**SUSITNA  
HYDROELECTRIC PROJECT**

FEDERAL ENERGY REGULATORY COMMISSION  
PROJECT No. 7114

**ALASKA POWER AUTHORITY  
COMMENTS  
ON THE  
FEDERAL ENERGY REGULATORY COMMISSION  
DRAFT ENVIRONMENTAL IMPACT STATEMENT  
OF MAY 1984**

**VOLUME 2B  
TECHNICAL COMMENTS  
-AQUATIC RESOURCES**

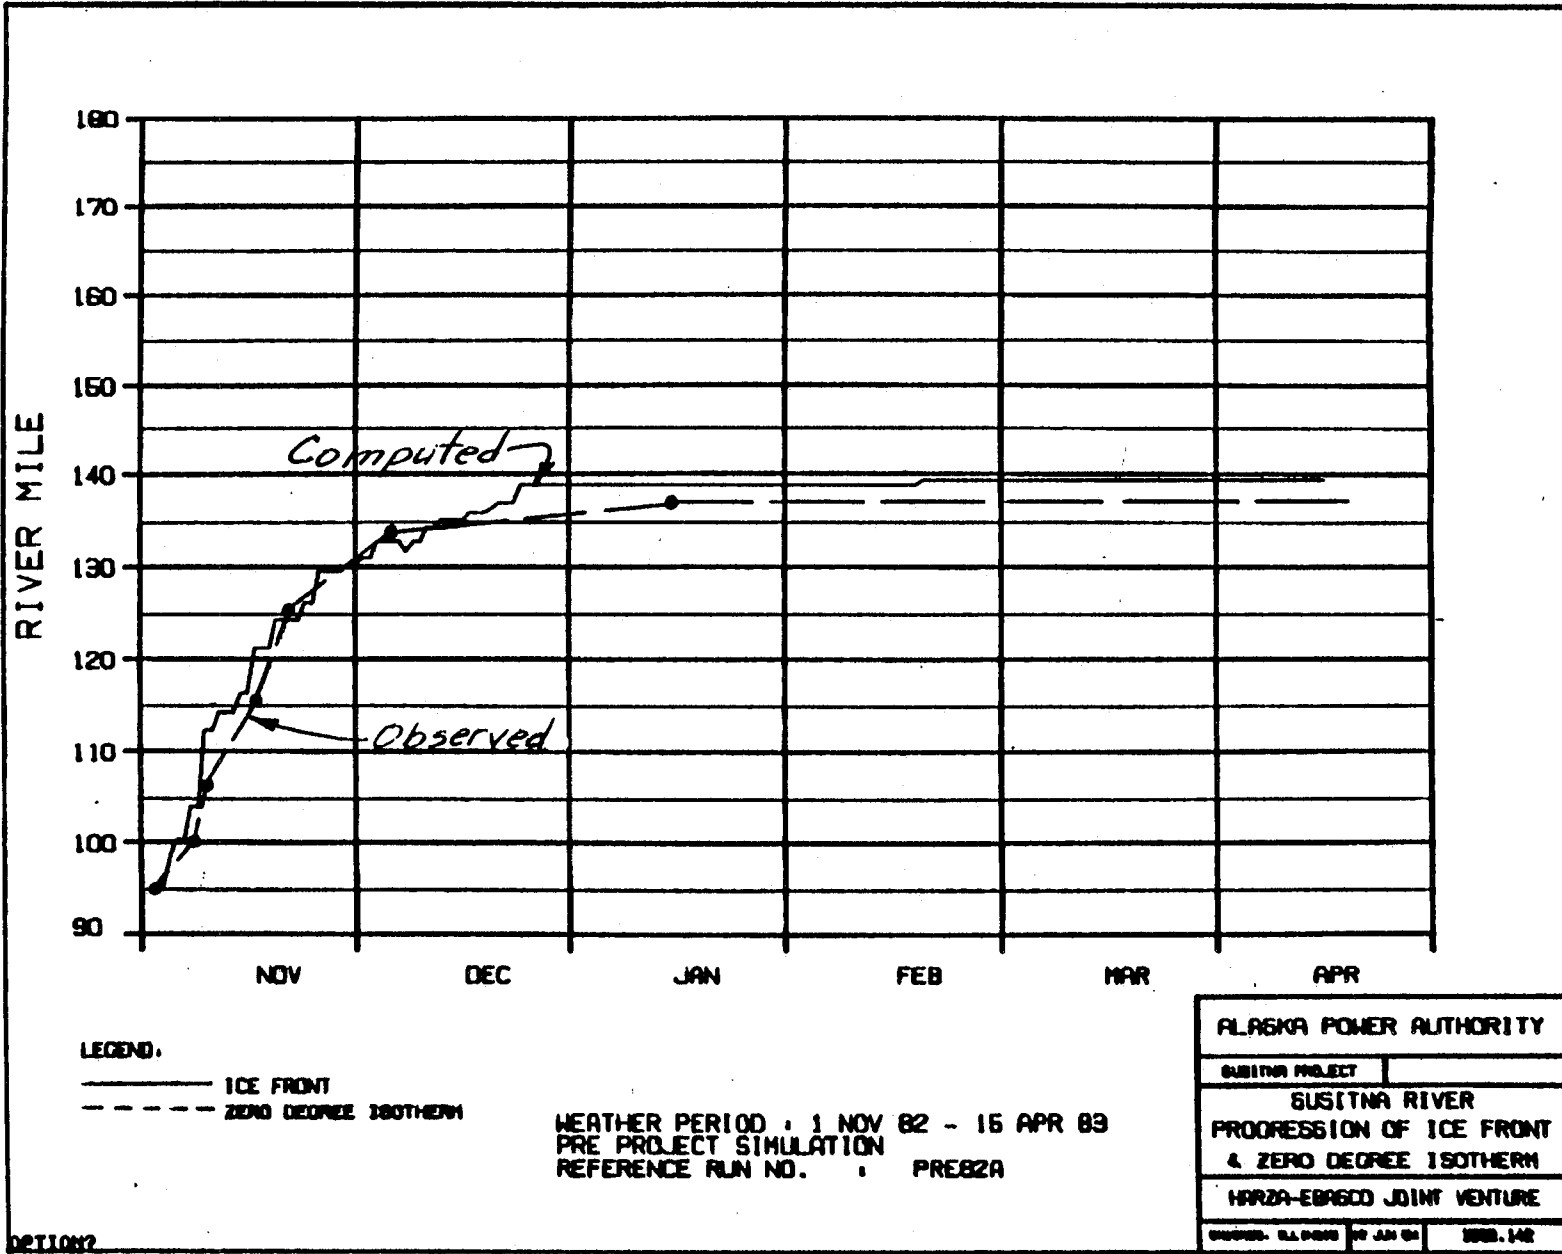
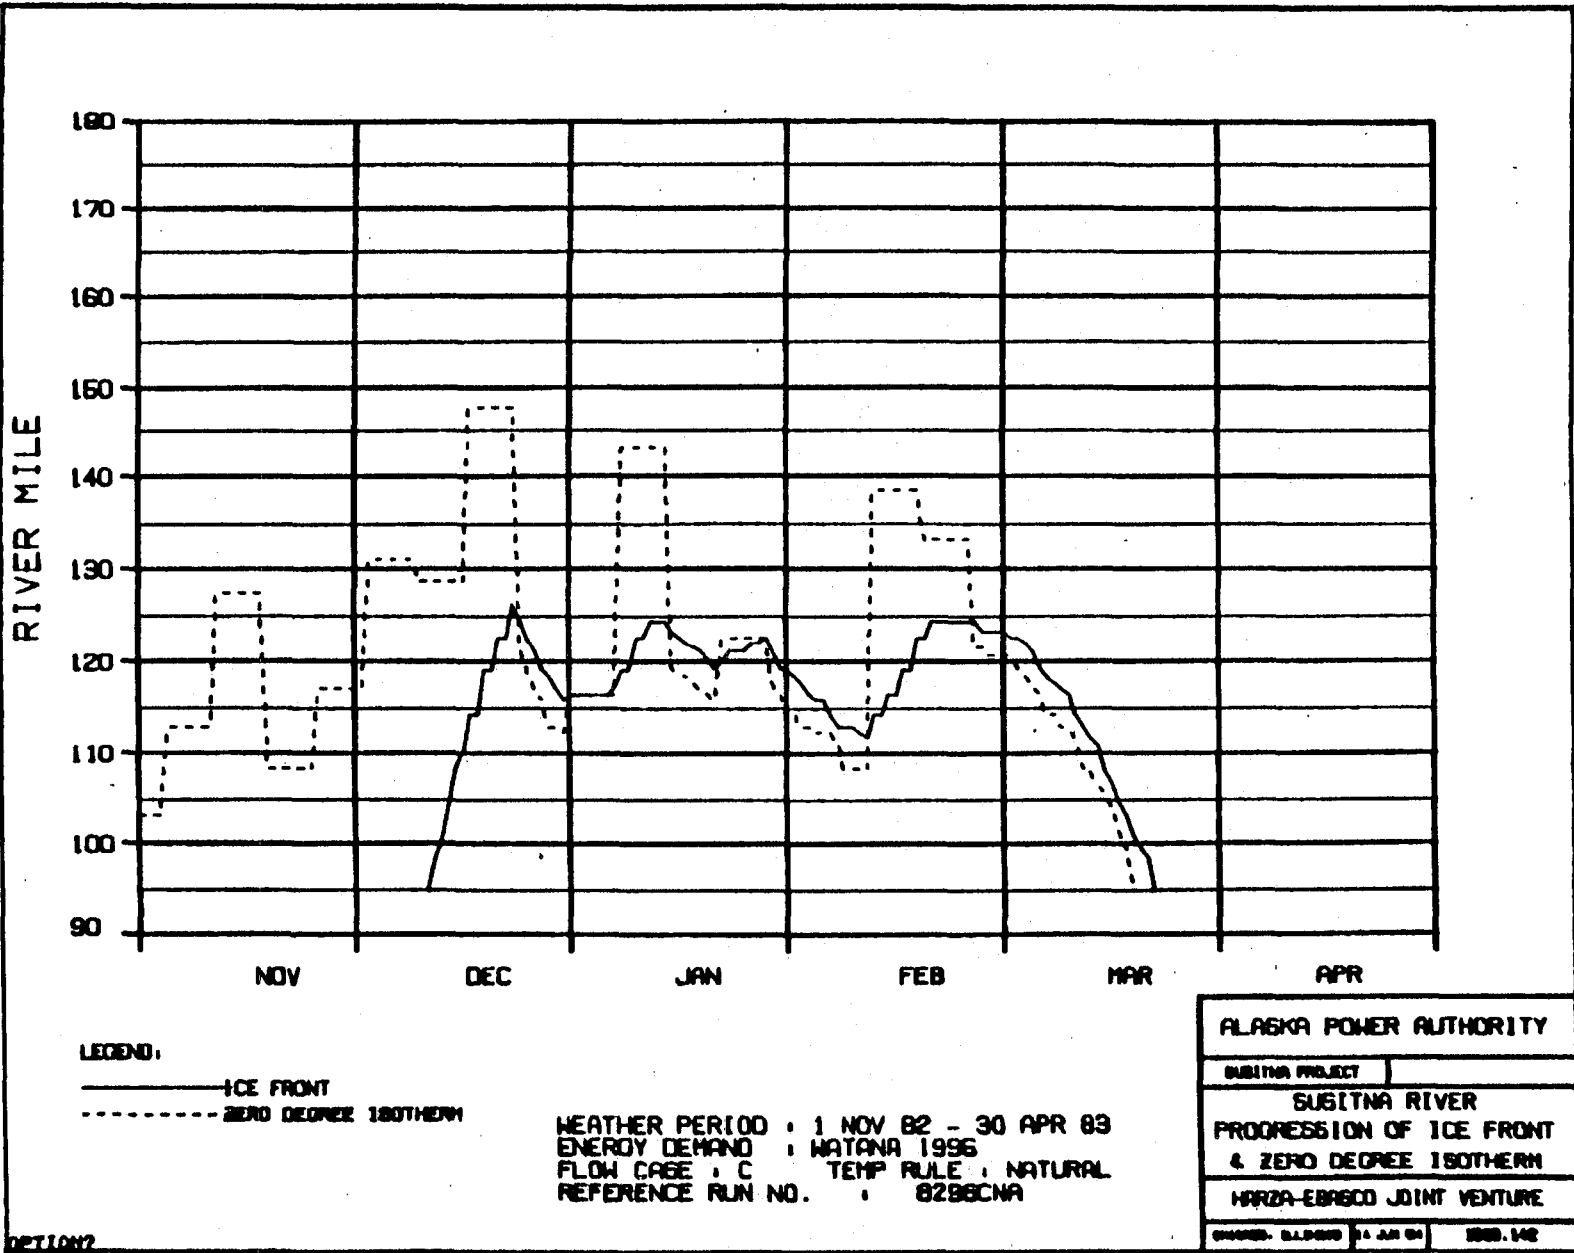
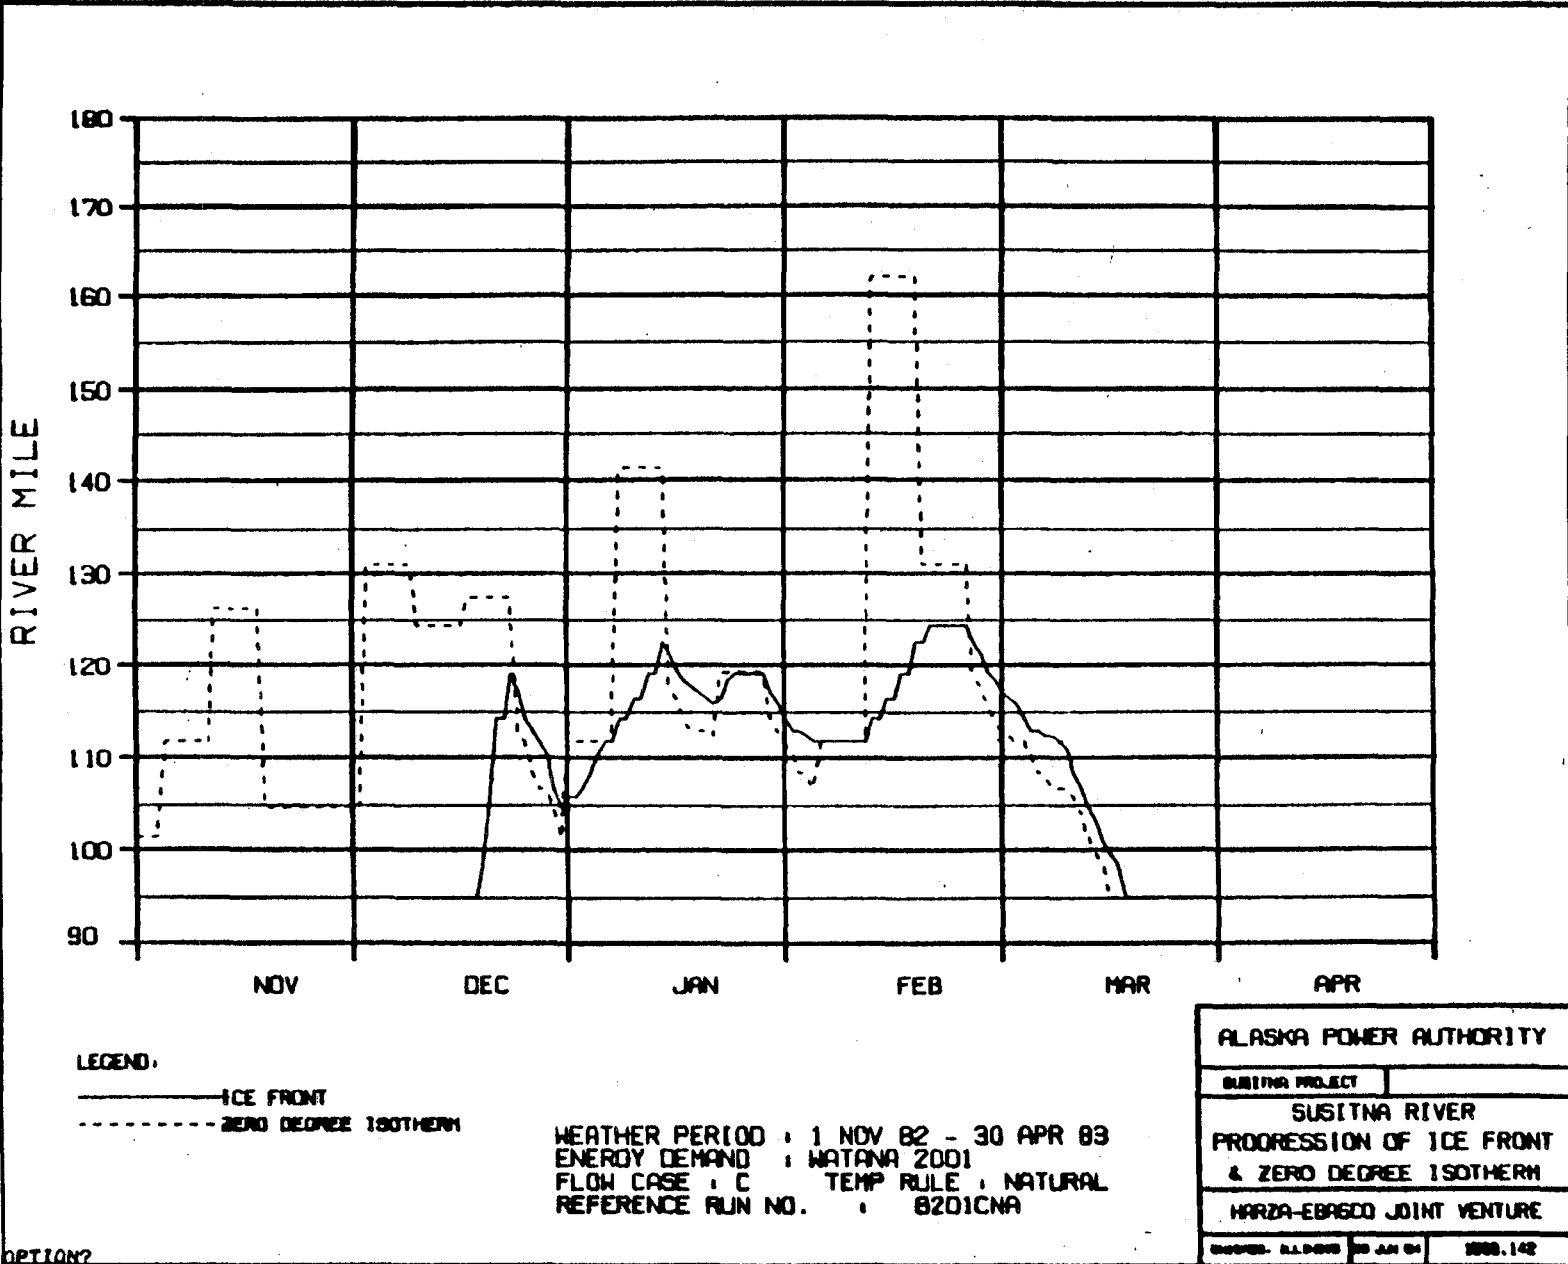
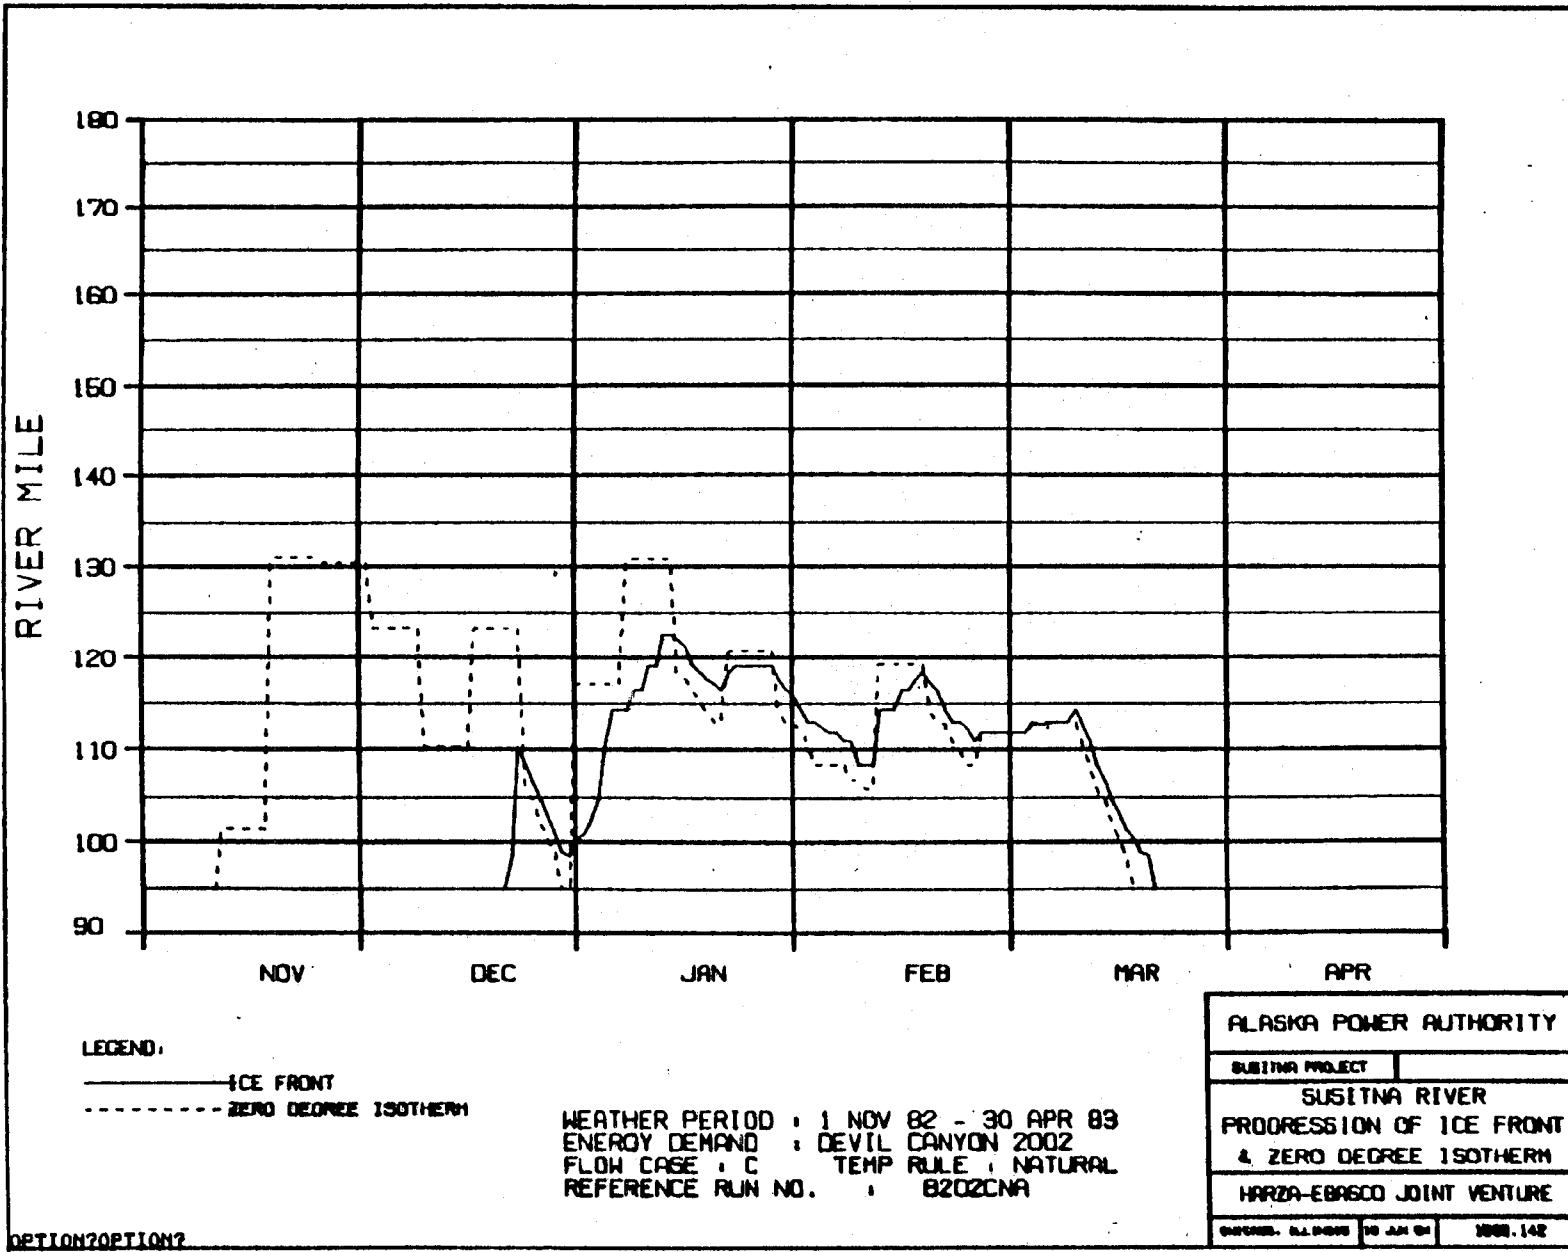
In cold winters such as 1981-1982, under natural conditions the ice front would be expected to reach Gold Creek in early January (Exhibit Q). With Watana only operating the ice front would advance to Gold Creek in late January (Exhibit G). With Devil Canyon operating the ice front would only advance to near River Mile 125, downstream of Slough 8A (Exhibit J).

The winter of 1971-1972 provided the fastest and furthest upstream progression of the ice front. For natural conditions the ice front would reach Gold Creek in mid-December (Exhibit O). With Watana only operating the ice front would reach Gold Creek in early to late January (Exhibits H and I) depending on the energy demand. With Devil Canyon operating the ice front would reach Gold Creek in early March for 2002 energy demands (Exhibit K). For Devil Canyon operating and 2020 energy demands the ice front would only advance to River Mile 133 (Exhibit L).

River ice simulations have also been made for the first and second winters of Watana filling. For the first winter when outflow would be made from the low level outlet and temperatures would be relatively warm the simulation was made using the 1982-1983 meteorological data which provide the mildest weather simulated. For this case the ice front would be expected to advance to near Gold Creek (River Mile 135) by mid-February. Maximum water levels would be similar to natural conditions. For the second winter of filling, outflows would be made from the midlevel outlet works (intake located at El. 2027), and outflow temperatures would be colder than in the first winter of filling. The winter of 1981-1982, a relatively cold winter was used to simulate river ice for this year. For this case the ice front would be expected to advance to near Gold Creek (River Mile 135) by early February (Exhibit N). For both the first and second winters of filling, border ice is expected to have a predominant influence on ice cover formation upstream of Gold Creek. This would be similar to natural conditions. Sufficient information was not available to allow accurate simulation of this process upstream of approximately River Mile 139 for the filling years.

The ice breakup (meltout) is expected to occur earlier with-project than under natural conditions. As indicated in Technical Comment AQR009 under natural conditions the river is generally open by mid-May. With-project the river upstream of the Chulitna-Susitna confluence may be open as early as mid-March for average winters such as 1982-1983 or as late as mid-May in very cold winters such as 1971-1972. With Devil Canyon operating with 2002 energy demands the river will generally be open 2 to 3 weeks earlier than with Watana only operating. With Devil Canyon operating and 2020 energy demands, the river upstream of the Chulitna-Susitna confluence would be open 2 to 3 weeks earlier than with 2002 demands. For filling of Watana reservoir the river would probably be open in mid-May similar to natural conditions.

With-project the ice is expected to be removed from the middle reach by meltout rather than breakup. The melting occurs generally before solar radiation becomes important. The melting is accomplished by above 0°C water reaching the ice front when air temperatures are not low enough to cool the reservoir outflow to 0°C.

The with-project meltout will generally take place over a longer time period than pre-project breakup. Exhibits A-R show meltout occurring in 2-4 weeks, whereas pre-project breakup generally occurs in 1-2 weeks.
